SUBJECT: NuScale Power, LLC Response to NRC Request for Additional Information No. 17 (eRAI No. 8767) on the NuScale Design Certification Application

NuScale Response to NRC Request for Additional Information eRAI No. 8767

NRC Question No.: 15.06.06-1

Figure 15.6-67: Inadvertent Operation of an Emergency Core Cooling System Valve – Critical Heat Flux Ratio

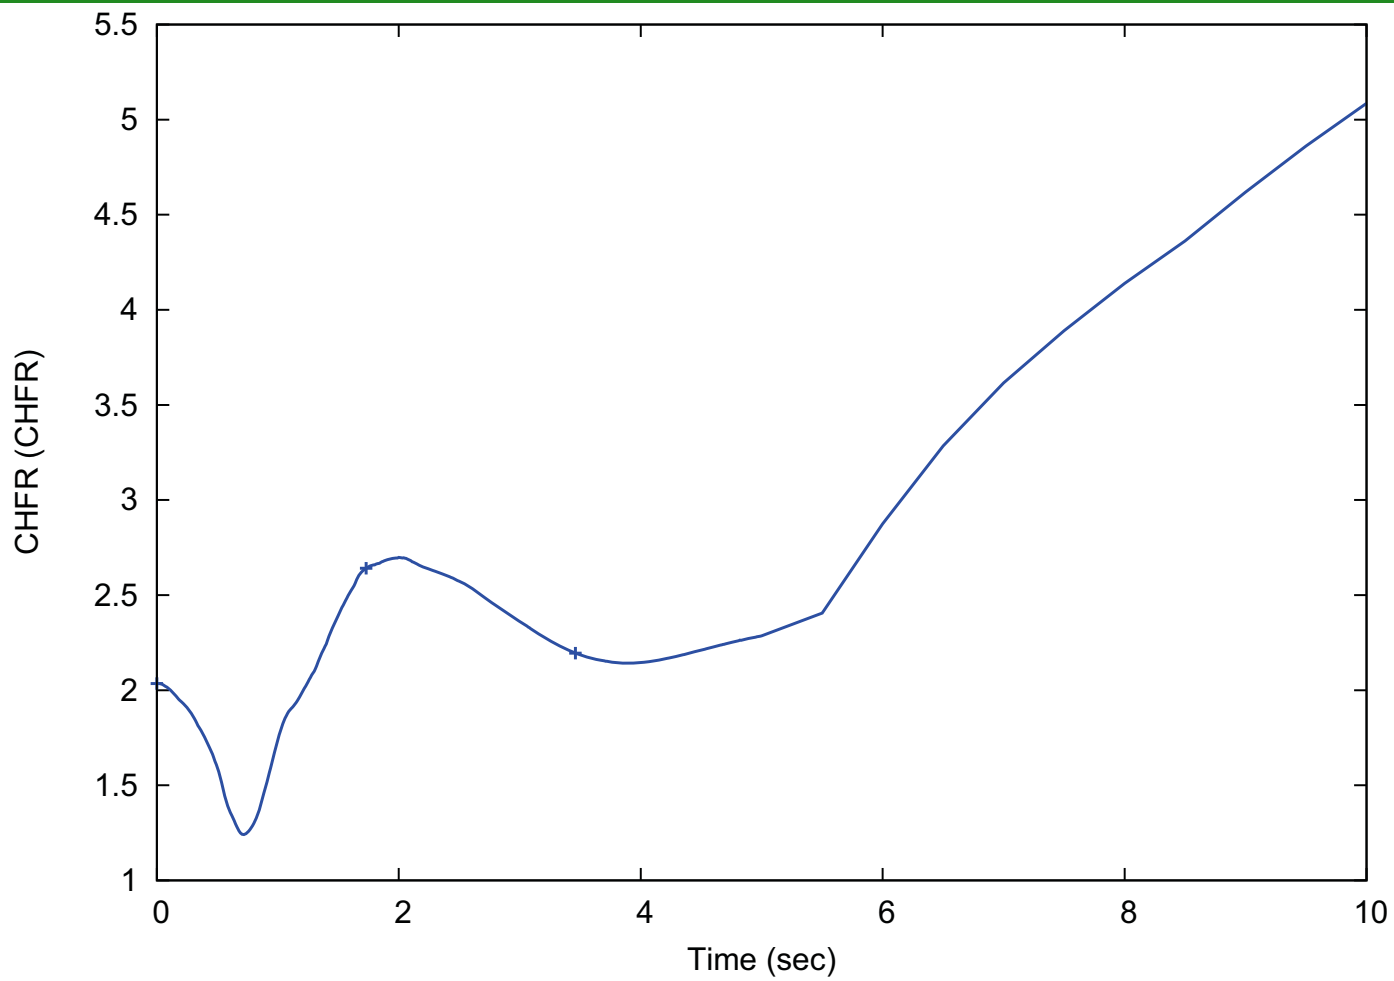
In FSAR Tier 2, Section 15.6.6, "Inadvertent Operation of Emergency Core Cooling System," the applicant does not provide a plot of minimum critical heat flux ratio (MCHFR). In accordance with DSRS Section 15.6.6, Review Procedure 7, the staff cannot determine if the MCHFR is acceptable for this event. The staff recognizes that the MCHFR is reported in FSAR Tier 2, Section 15.6.6.6, "Conclusions." However, this does not allow the staff to assess the MCHFR throughout the transient to verify when and where the MCHFR occurs. Based on the docketed information, the staff cannot determine if abundant core cooling is provided during the accident and will prevent fuel and clad damage that could interfere with continued effective core cooling. The staff requests the applicant to provide additional plots in the FSAR of MCHFR for the entire transient ("zoomed-in" and "zoomed-out") that show how the MCHFR behaves as the transient progresses.

A plot of the "zoomed-in" critical heat flux ratio (CHFR) has been added to FSAR Section 15.6.6 as FSAR Figure 15.6-67 and a "zoomed-out" CHFR plot has been added as FSAR Figure 15.6-68. FSAR Figure 15.6-67 confirms that the minimum CHFR (MCHFR) is 1.240 and that MCHFR occurs shortly, within one second, after event initiation, as reported in FSAR Section 15.6.6.5. FSAR Section 15.6.6.5 states that the MCHFR is above the CHFR limit. Figure 15.6-68 provides CHFR for the duration of the event.

The fuel integrity is not challenged by the spurious opening of the RVV. The fuel temperatures decrease upon the reactor trip, as shown in Figure 15.6-65 and Figure 15.6-66, and the water level remains above the top of the active fuel, as shown in Figure 15.6-62. The MCHFR is 1.240, [as shown in Figure 15.6-67 and Figure 15.6-68](#), which is greater than the 95/95 limit of 1.122. As noted in Section 15.6.6.3.1, MCHFR occurs in the high flow correlation range shortly after event initiation as reactor power is still elevated at this time.
